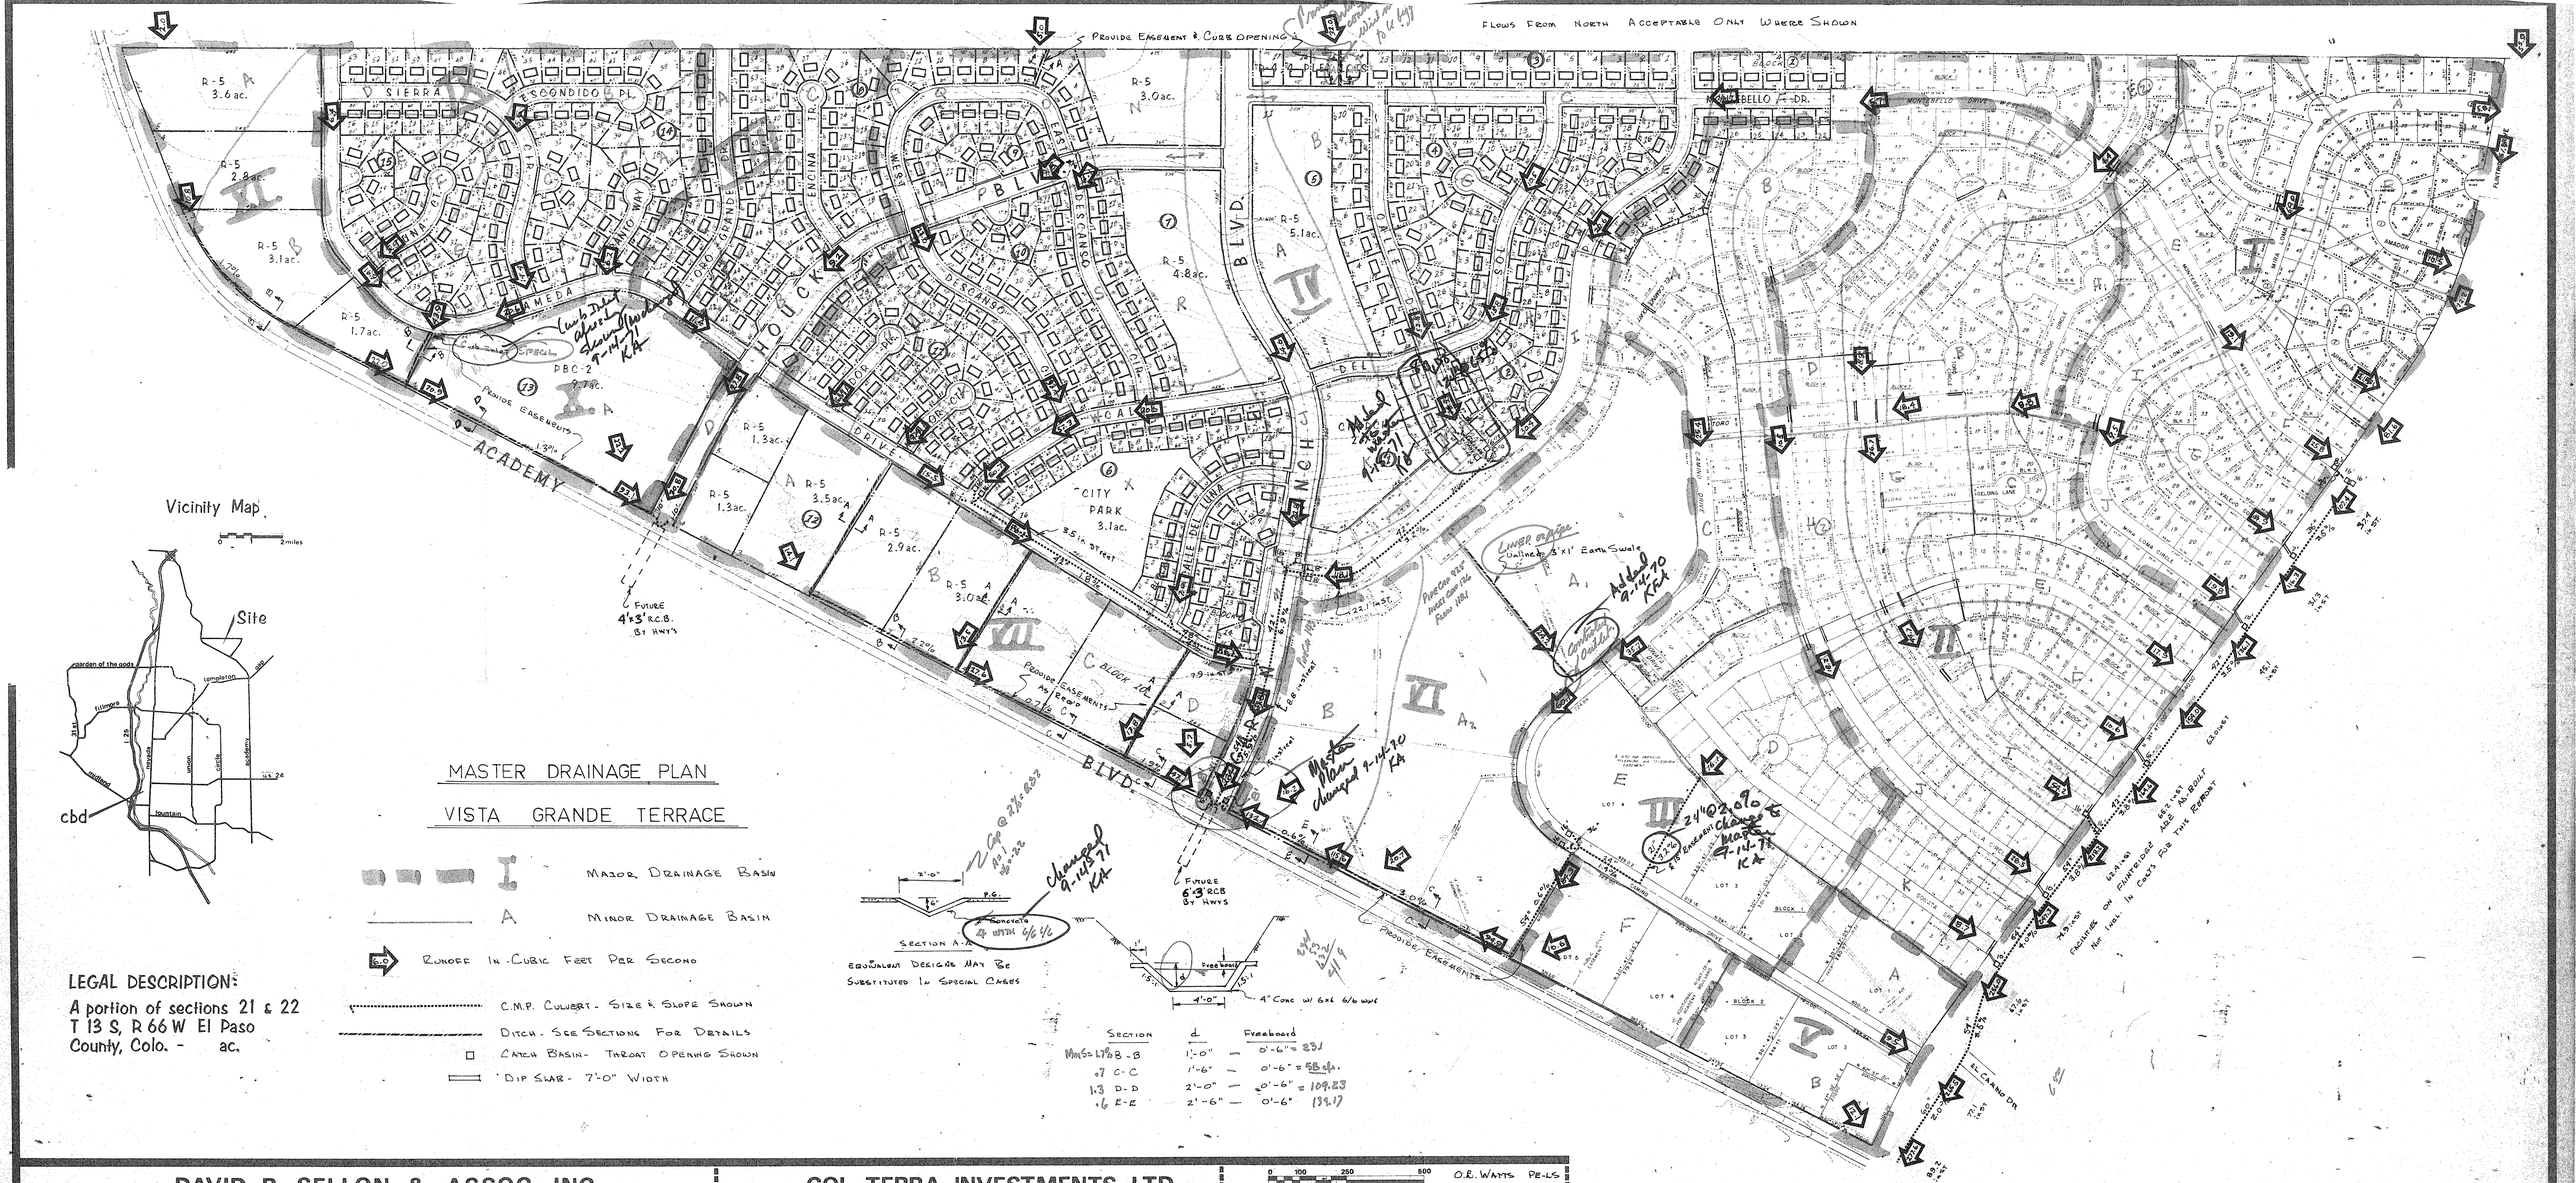
FLOWS FROM NORTH ACCEPTABLE ONLY WHERE SHOWN
PROVIDE EASEMENT & CURB OPENING
R-5 3.6 ac.
R-5 2.8 ac.
R-5 3.1 ac.
R-5 1.7 ac.
R-5 7.7 ac.
R-5 1.3 ac.
R-5 1.3 ac.
R-5 3.5 ac.
R-5 2.9 ac.
R-5 3.0 ac.
R-5 3.0 ac.
R-5 4.8 ac.
R-5 5.1 ac.
SIERRA
ESCONDIDO PL.
ALAMEDA
HOUCK
CITY PARK 3.1 ac.
ACADEMY BLVD.
PBC-2
FUTURE 4'x3' R.C.B. BY HWY'S
FUTURE 6'x3' RCB BY HWYS
PROVIDE EASEMENTS
Vicinity Map
Site
garden of the gods
fillmore
platte
circle
cbd
mountain
union
nevada
tejon
cascade
academy
uintes
completion
MASTER DRAINAGE PLAN
VISTA GRANDE TERRACE
MAJOR DRAINAGE BASIN
MINOR DRAINAGE BASIN
RUNOFF IN CUBIC FEET PER SECOND
C.M.P. CULVERT - SIZE & SLOPE SHOWN
DITCH - SEE SECTIONS FOR DETAILS
CATCH BASIN - THROAT OPENING SHOWN
DIP SLAB - 7'-0" WIDTH
LEGAL DESCRIPTION:
A portion of sections 21 & 22
T 13 S, R 66 W El Paso
County, Colo. - ac.
SECTION A-A
EQUIVALENT DESIGN MAY BE SUBSTITUTED IN SPECIAL CASES
4" Conc w/ 6x6 6/6 wwf
SECTION d Freeboard
MAJOR STR B-B 1'-0" — 0'-6" = 23 cfs

C-C 1'-6" — 0'-6" = 58 cfs
D-D 2'-0" — 0'-6" = 109.23
E-E 2'-6" — 0'-6" 139.17
Master Plan changed 9-14-70 KA
Changed 9-14-70 KA
Changed 9-14-71 KA
Added 9-14-70 KA
LOWER ortho
Outlined a 3'x1' Earth Swale
Provide R.O.W. Note Conc. Flow Line
Provide R.O.W. Note Conc. Flow Line
Provide Easements
Provide Easements
Provide Easements
